SUBDIVISION COMMITTEE
METROPOLITAN AREA PLANNING COMMISSION

STAFF REPORT
(Preliminary Plat)

CASE NUMBER: S/D 93-59 WALTANA ESTATES

STAFF REPORT
(Final Plat, Preliminary Plat Approved 9/30/93)

VICINITY MAP:

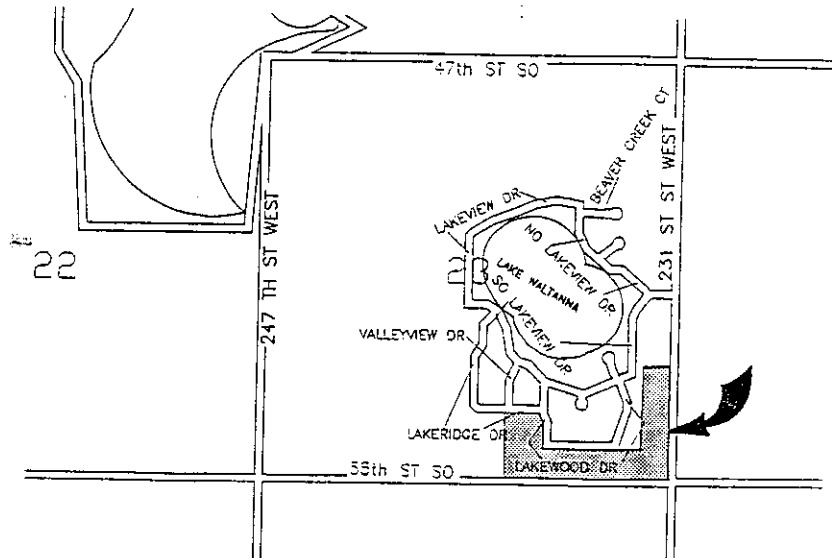
NOTE: The Miles Country Club Estates Addition to the north of this site was platted with public streets. However, Lakewood Drive immediately north of Lots 5, 6, and 7 of this plat is only shown as having half of the street created by the Miles Plat; the remaining or southern portion of this street segment apparently having been dedicated in some other manner (separate instrument). Based upon this preliminary plat, not only was the southern portion of this street dedicated separately rather than being platted, but Reserve strips have apparently been purposely created to prevent property from the south the use of this street. Overall, the area to the north has been platted into approximately 100 residential lots with only one point of entrance being provided from 231st Street West. Although this Addition is proposing only 8-lots, all of these lots are indicated as requiring access from the adjacent arterials rather than through an interior residential street such as Lakewood Drive.

- A. The Subdivision Regulations indicate that residential lots should be oriented such that access is provided from interior streets rather than directly onto adjacent arterials such as 55th Street South and 231st Street West. In terms of this plat, a public street could/should be considered along the north line of Lots 3, 4 and 5 which would connect to Lakewood Drive just south of Lot 9, Block 8 of the Miles Country Club Estates Addition. Such a street would also provide the Miles Addition with a second point of entrance for emergency purposes.

However, as indicated in the note such a street may be precluded from being provided due to the indicated Reserves. Also, a significant section of such a street would be next to and within a Pipeline easement. Such a pipeline easement may also have conditions that would prevent a street, even if unpaved from being placed over the easement.

The applicant's agent should be prepared to discuss the possibility of the above indicated street. Information and recorded documents shall be submitted which indicate how the southern half of Lakewood Drive and the Reserves were created and that public access has consequently been restricted to this street from this site. Also a copy of the pipeline easement needs to be provided and reviewed by the agent noting if any restrictions for a public street exist within the easement agreement. Unless prohibited by any of these conditions, the final plat shall be redesigned with a public street extending from 231st Street West across the northerly line of Lots 3, 4, & 5

to a connection with Lakewood Drive. Such a revised plat shall be submitted as a preliminary so that appropriate conditions can be determined for such a revised plat.

- B. As required by the Subdivision Regulations for a multilot residential addition anticipating to use on-site water and sanitary sewer (lagoons), all lots shall at a minimum, exclusive of street right-of-way, contain at least 5-acres. Lots 3 through 7 of this plat range from 3.7 acres to 4.6 acres. Unless this site (lots) can be approved for septic systems, the final plat shall be reconfigured such that only 4-lots are shown in the area now occupied by Lots 3, 4, 5, 6 and 7. That is, one less lot shall be platted.

- D. The applicant shall guarantee any drainage improvements required by the platting of this property.
- E. On the final plat tracing and within the platting's text, access controls shall be indicated to 55th and 231st Streets. Except for the lot at the intersection, access control except for (1) one opening shall be dedicated. For the lot at the intersection, while 1-opening may be indicated to each street, 100-feet of complete access control shall be noted from this lot's southeast corner and extending back along both streets.

- F. The applicant shall submit a copy of the instrument which establishes the high pressure gas pipeline Easement on this property. The applicant's agent shall determine any setback requirements from the pipeline by researching the text of the pipeline agreement. If a setback from the pipeline easement is provided for in the pipeline easement agreement, it shall be indicated on the face of the plat.

- J. On the final plat, additional dimensions shall be indicated from the lot corners to the pipeline (easement) so as to precisely locate the pipeline on these lots.

VICINITY MAP:

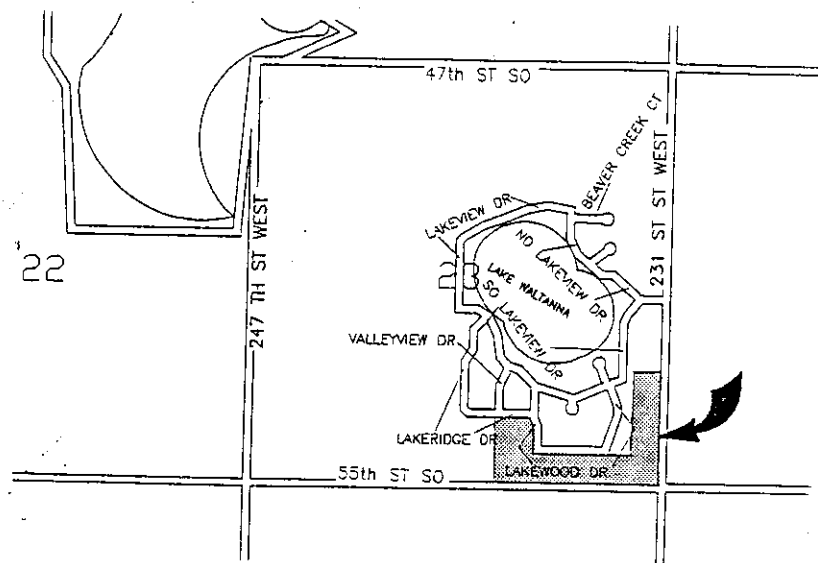
- A. As required by the Subdivision Regulations for a multilot residential addition anticipating to use on-site water and sanitary sewer (lagoons), all lots shall at a minimum, exclusive of street right-of-way, contain at least 5-acres. Lots 3 through 7 of this plat range from 3.7 acres to 4.6 acres. Unless this site (lots) can be approved for septic systems, the final plat shall be reconfigured such that only 4-lots are shown in the area now occupied by Lots 3, 4, 5, 6 and 7. That is, one less lot shall be platted.

- C. On the final plat tracing, the areas of "complete access control" for Lot 3 shall also be labeled on the face of the plat.
- D. The applicant shall submit copies of the instruments which establish the Kansas Gas Supply and Gas Service Company Easements on this property. The applicant's agent shall determine any setback requirements from the pipelines by researching the text of the pipeline agreements. If setbacks from the pipeline easements are provided for in the pipeline easement agreements, they shall be indicated on the face of the plat.

- E. According to the platting binder, The Drillers Gas Company holds an easement on this site. A review of that easement appears to indicate that this is a blanket easement. No information indicates that this easement has been released or confined. Prior to releasing this plat for County Commission review, the applicant shall provide proof that this easement has been released or confined to another easement either now being shown on the plat or if need be shall be shown on the final plat tracing.

- H. On the final plat tracing, additional dimensions shall be indicated from the lot corners to the Kansas Gas Supply Pipeline (easement) so as to precisely locate the pipeline on these lots.

- I. Since this plat is now indicating the platting of a floodway, the plattor's text shall reference the standard floodway language. If a minimum building pad elevation is required, this shall also be noted in the plattor's text in addition to being shown on the face of the plat. It shall be indicated if such elevation is for the lowest floor or opening level and both on-site and off-site benchmarks shall be noted.

- J. The final plat tracing shall indicate the utility easements requested by K.G.& E. - Gas and Electric which were indicated on the "marked" copy of the preliminary plat previously supplied to the applicant. The applicant shall also submit a letter from KG&E indicating that arrangements have been made for the relocation of any KG&E facilities not being covered by an easement.
